**CITY OF TEMPE  
DEVELOPMENT REVIEW COMMISSION**

**Meeting Date: 01/14/2020  
Agenda Item: 10**

**ACTION:** Request a Use Permit Standard for side yard reduction from 10’ to 8’ and a Development Plan Review for four new single-story single-family homes for 19TH STREET RESIDENCES located at 667 West 19th Street. The applicant is Habitat for Humanity.

19<sup>th</sup> STREET RESIDENCES  
(PL190298)

# SITE PLAN FOR 19TH STREET HOMES 19TH STREET AND MCKEMY STREET

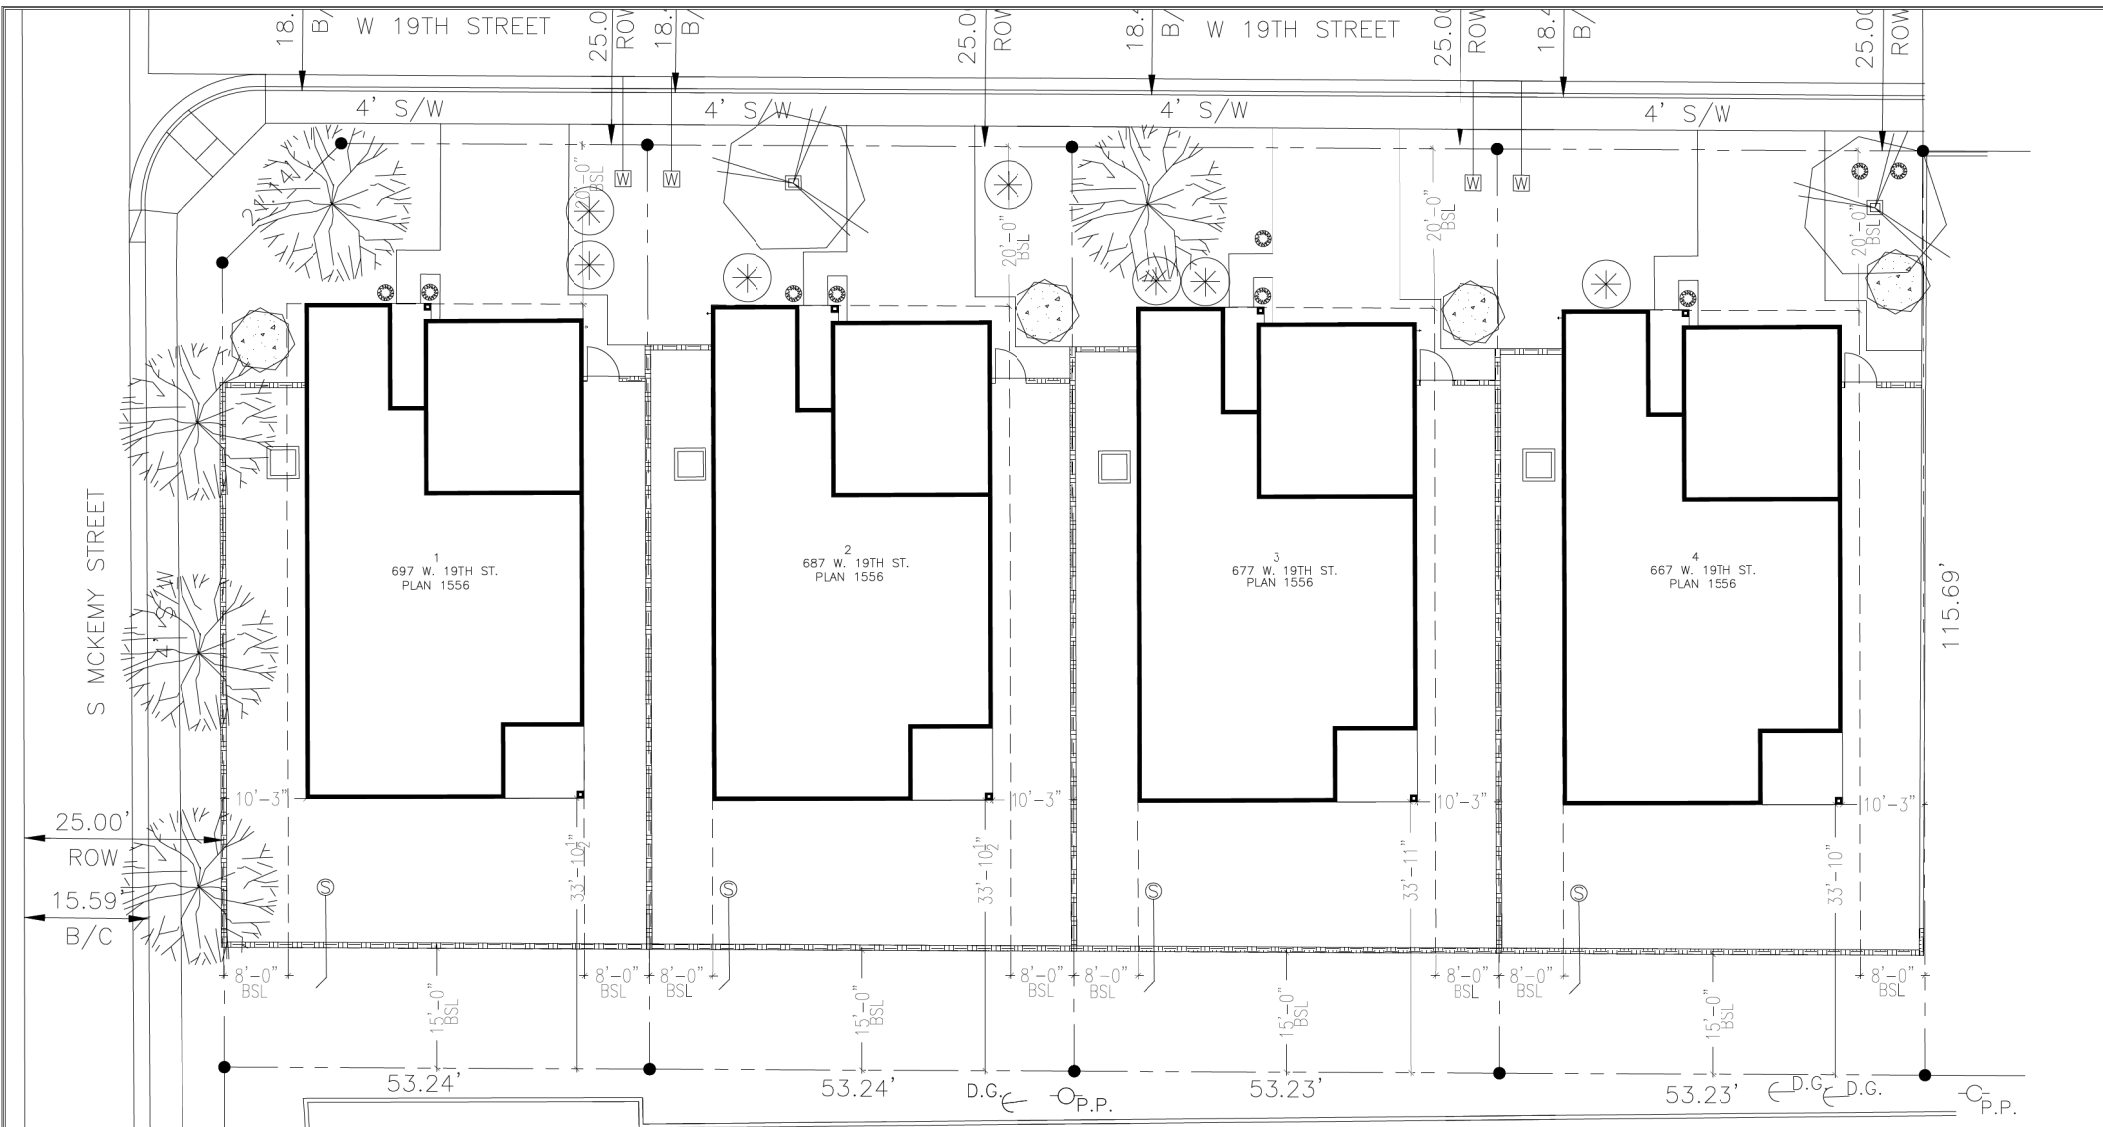
The four units are oriented north facing the park and south facing the back yard. Windows and doors are located on both front and back, and smaller windows are located on the sides. The yards are 20' deep in the front, with full length driveways to each garage. The rear yards are 15' deep, with walls located 15.67' north of the actual property line, to accommodate the existing alley easement. Side yards are 8' from wall of home to property wall, providing 16' between each unit. Trash and recycle cans are stored in the side yard, with gate access to 19<sup>th</sup> street for refuse and recycling staging at the street front. The yards will have 6' cmu walls with gates.

1. Except as modified by conditions, development shall be in substantial conformance with the site plan and building elevations dated December 17, 2019 and landscape plan submitted on December 23, 2019. Minor modifications may be reviewed through the plan check process of construction documents; major modifications will require submittal of a Development Plan Review.

**LANDSCAPE PLAN**  
**HABITAT FOR HUMANITY**  
 TEMPE, AZ 85281  
 CENTRAL ARIZONA  
 9133 NW GRAND AVE  
 PHOENIX, AZ 85045  
 O: 623.583.2417  
 ROC 251891

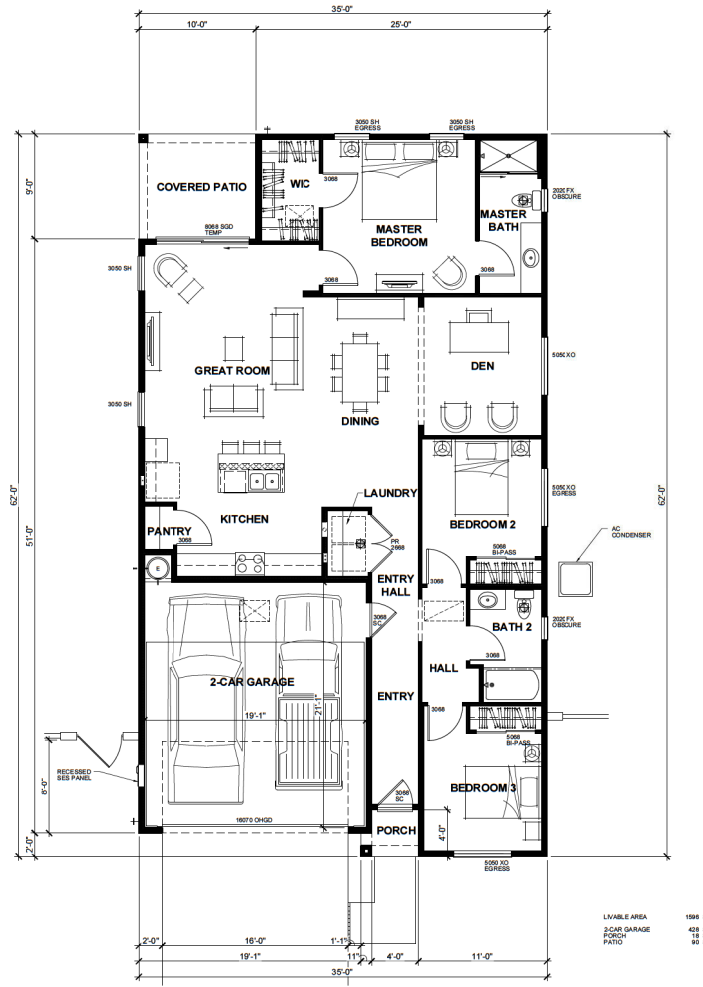
6. Although the color elevations showed lush plants at the base of the building, the landscape plan did not include these plants or meet design standards for front yards. Trees are only 10.5 gallon and yards are predominantly gravel. Staff has conditioned the landscape plan to include 1 ½" caliper trees and a palette option for a mix of ground cover and shrubs to provide more vegetative ground cover.

8. Recommendations were made for the planting plan, but the landscape plans did not provide sufficient plant variety or quantity to meet design criteria.

The landscape plan provides residents with a choice of two trees, either Thornless Mesquite or Palo Verde, the plan has a choice of two shrubs, Cassia or Sage, and one ground cover, Red Yucca. Staff has conditioned the proposed planting plan to provide more biodiversity and more vegetative ground cover.

8. Each lot owner shall be given the choice of four of any of the following combinations of 3-5' shrubs: Silver Cassia, Texas Sage, Tecoma stans 'sparky', Ruellia peninsularis, Bougainvillea, Mexican Bird of Paradise, Eremophila valentine and/or Hop bush.

9. Each lot owner shall be given the choice of seven of any of the following combinations of 2'-3' ground covers: Red Yucca, Eremophila glabra, Muhlenbergia, Rosemary, Gold Lantana, Bush Morning Glory, Acacia redolens.

10. The McKemy Street side yard shall have three street trees of one of the following species, per the owner's selection: either Evergreen Elm, Chinese Pistache or Heritage Oak, and shall be a minimum of 1 ½" caliper.

11. The McKemy Street side yard shall have three shrubs from the 3-5' plant list of the owner's choice, spaced between the trees along the west side of the wall and three ground covers from the 2' plant list planted at the corner of the lot at the intersection of the streets adjacent to the sidewalk; these six plants are located within the right of way and are in addition to the front yard landscape.
